# PORTLAND MAINE

September 13, 2012

**RE: 433 Fore Street – Canal Plaza Hotel**  
**Level III Site Plan Review**  
**Application ID Number: 2012-558**

**EXISTING CONDITIONS SURVEY**  
 PORTION OF 1 CANAL PLAZA, PORTLAND, MAINE

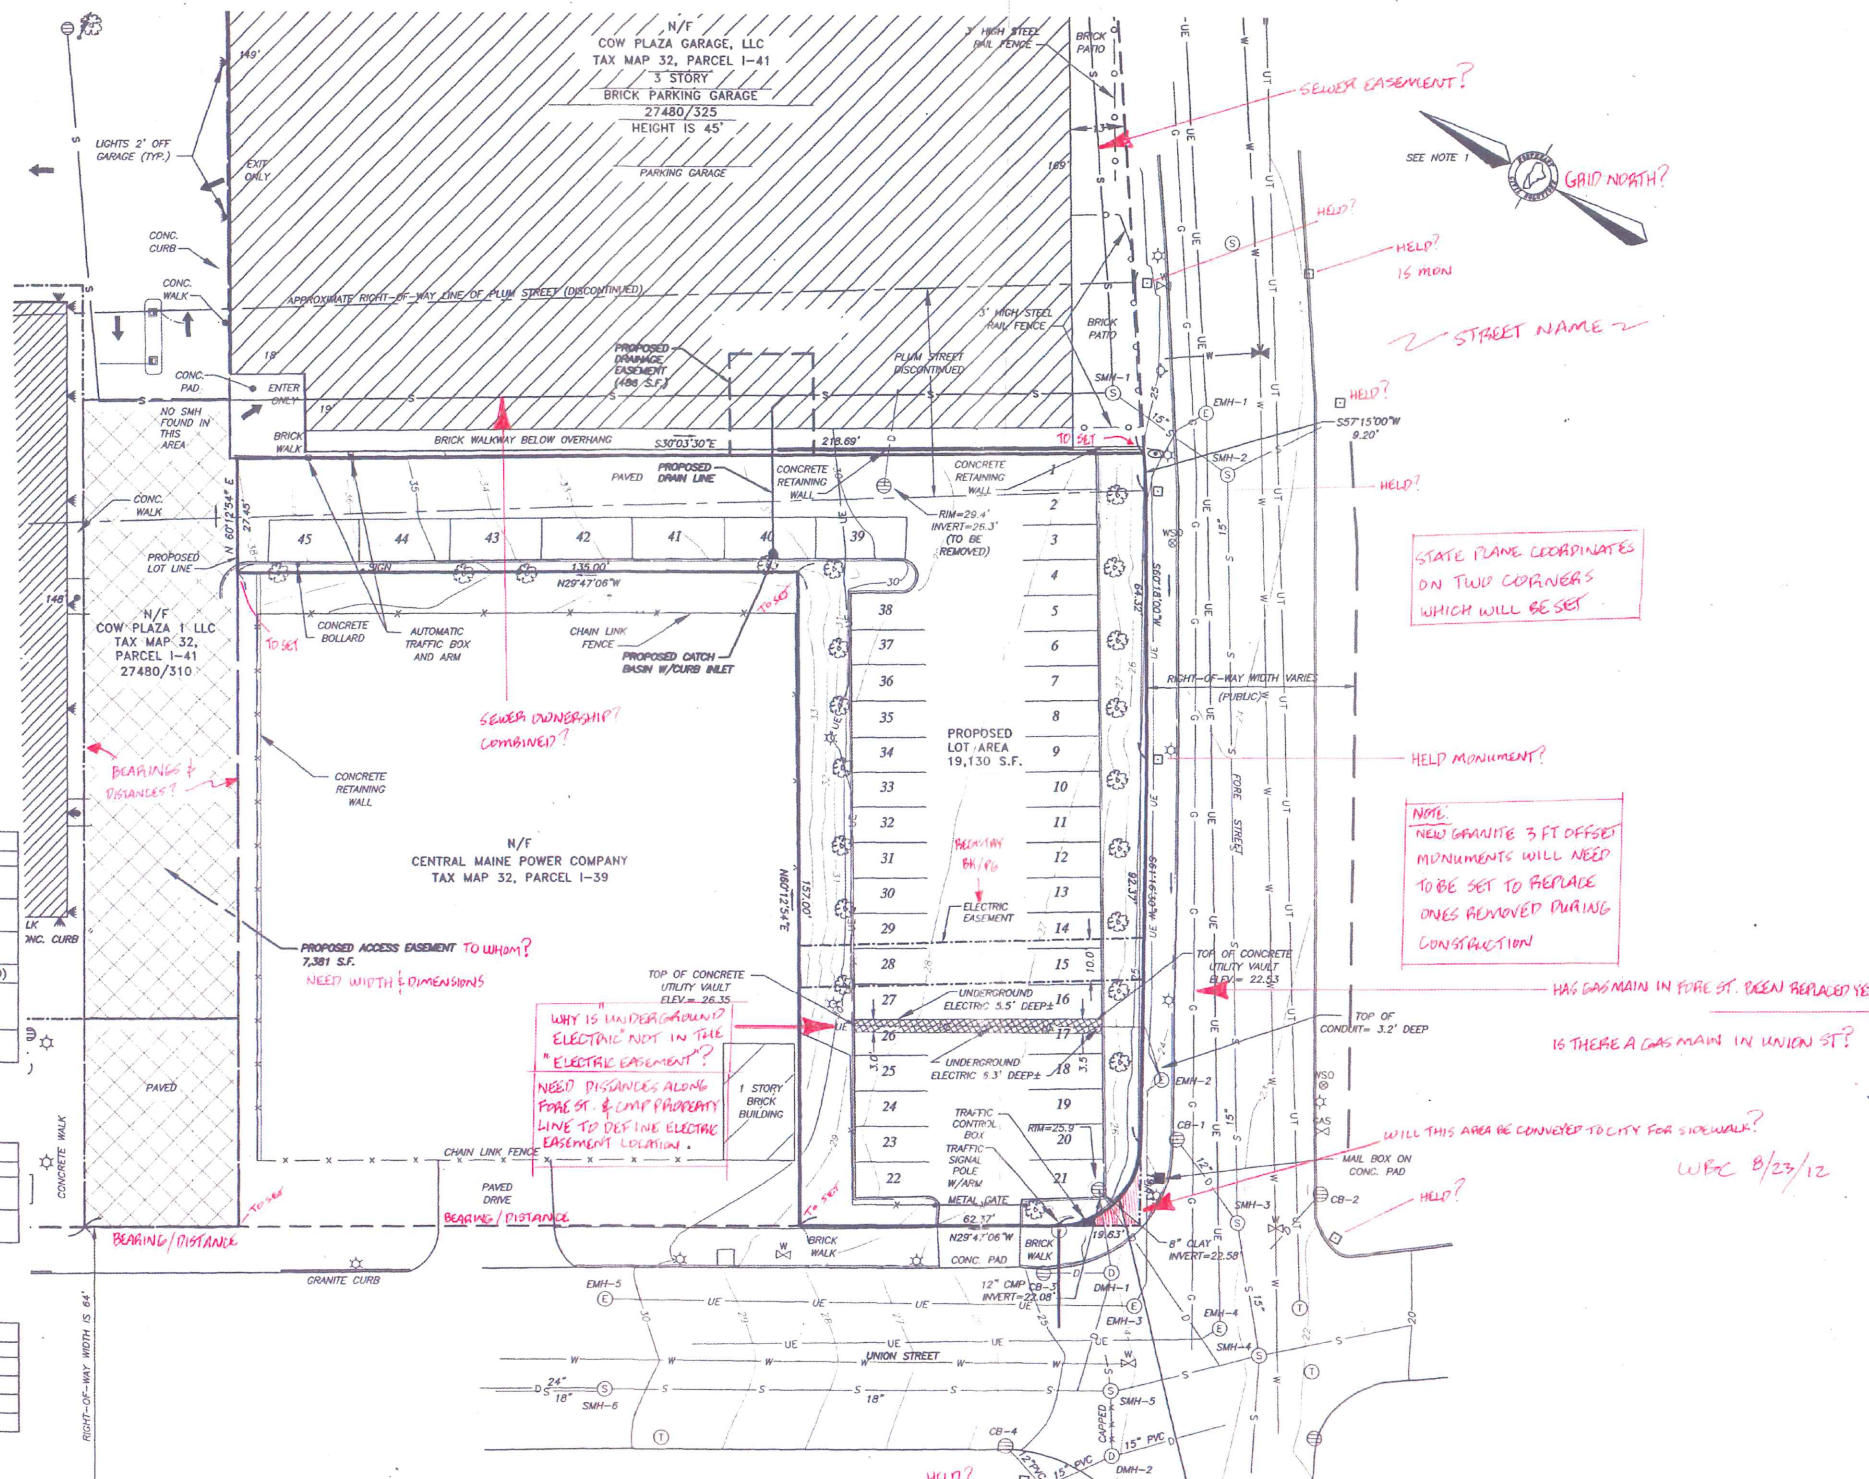
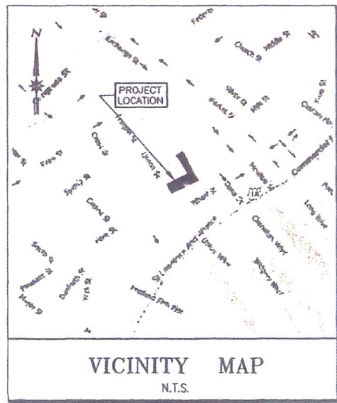
- UTILITIES SHOWN HEREON WERE TAKEN FROM THE PLANS REFERENCED IN NOTES 4.a., 4.b., 4.g., AND 4.h.
  - CONTOURS AND ELEVATIONS ARE NGVD 1929 DATUM.
  - WHAT CITY BENCHMARK WAS USED?
